# VEHICLE RECALL

**AMERICAN TRANSPORTATION RECALL # 01304**  
**NHTSA RECALL # 01V-270**

**SUBJECT: VEHICLE RECALL**  
**Accelerator Pedal Interference with Floor Mat**

**Picture with Engine Cover Removed**

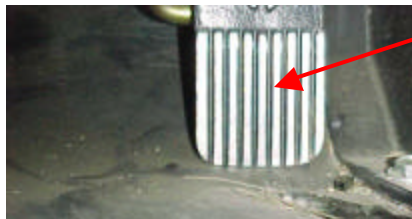
These units with the combination of an I6 engine, plywood floor and driver insulation package can decrease the distance from the accelerator pedal to the floor. If the operator depresses the lower portion of the accelerator pedal with the toe of his shoe, the pedal will pivot to a vertical position. When the pedal is in this position and pushed forward to accelerate, the bottom edge of the pedal could interfere with the floor mat and stick, causing the throttle to remain in a partial or full position.

**Pedal Held in Vertical Position**

**Contact with Floor**

**Picture showing pedal depressed to full throttle position**

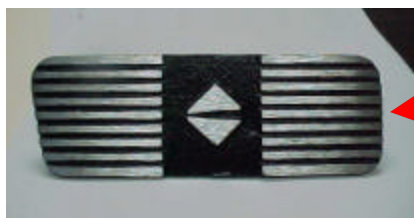
Inspect the identified bus for this defect using the following procedures. With the engine off and using your fingers, depress the accelerator to the full throttle position by pressing on the lower portion of the pedal only. If the pedal sticks to the floor mat during this inspection, it must be repaired before returning to service. See repair instructions below.

**Press pedal here with your fingers**

This recall requires each bus to be inspected as described above for a minimum clearance of  $\frac{1}{4}$  inch between the lower edge of the pedal and the floor mat and/or the metal engine cover plate.

The repair procedure involves removing the accelerator pedal from the bus and removing  $\frac{1}{2}$  inch of material from the lower end. The following steps must be followed to repair the defect.

1. Remove the accelerator pedal/rod assembly by removing two screws attaching the pedal rod to the electronic control unit.

**Remove these two screws**

2. Cut ½ inch from the bottom (non-tapered edge) of the pedal and grind/file the cut edge to remove sharp burrs.

**Remove ½ inch of material from this end of the pedal**
